WORK CHANGE DIRECTIVE

No. 8

Owner: St. Charles Parish
Contractor: Sealevel Construction
Contract: Ellington Drainage Pump Station
Project: Ellington Drainage Pump Station
Owner's Contract No.: P080905-5D Engineer's Contract No.: 10475-323
ENGINEER: Burk-Kleinpeter, Inc.

Contractor is directed to proceed promptly with the following change(s):
Description: Supply and install a drain line with three catch basins. Also, add incidental concrete pavement for a sidewalk.

SITE PLAN
SCALE 1" = 10'

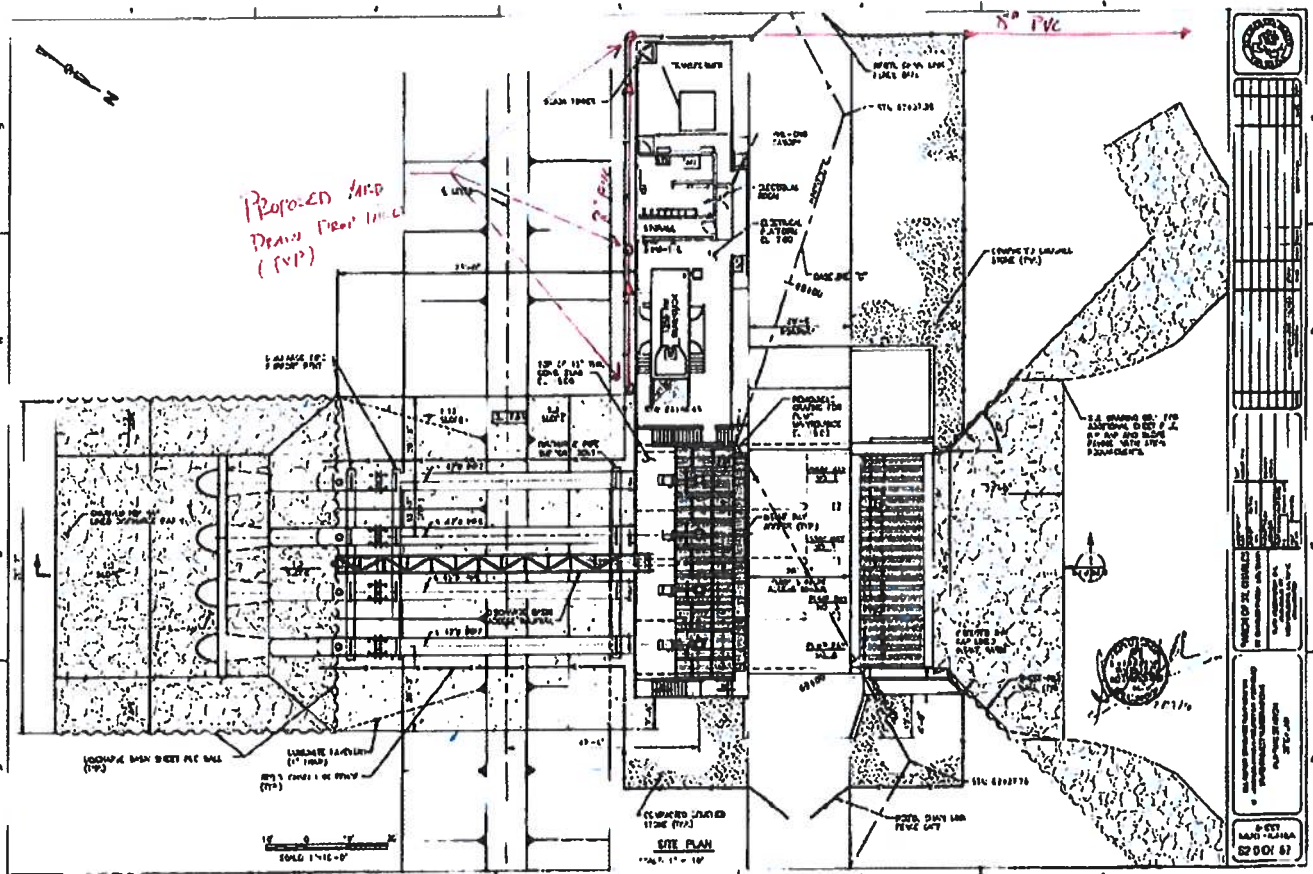
1. Change Order Request is for the addition of approximately 215 LF of 8" drainage pipe to be added to the South side of the generator concrete pad as per the attached drawings. The COR includes the addition of three (3) plastic drainage catch basins. The pipe will drain to the canal on the West side of the station.
2. COR assumes that the outfall will be open ended and not include any trash screens nor backflow preventer at discharge.
3. COR is for two (2) additional days be added to the current contract time.

*Proposed 8" PVC
Drains from 110's
(RVP)*
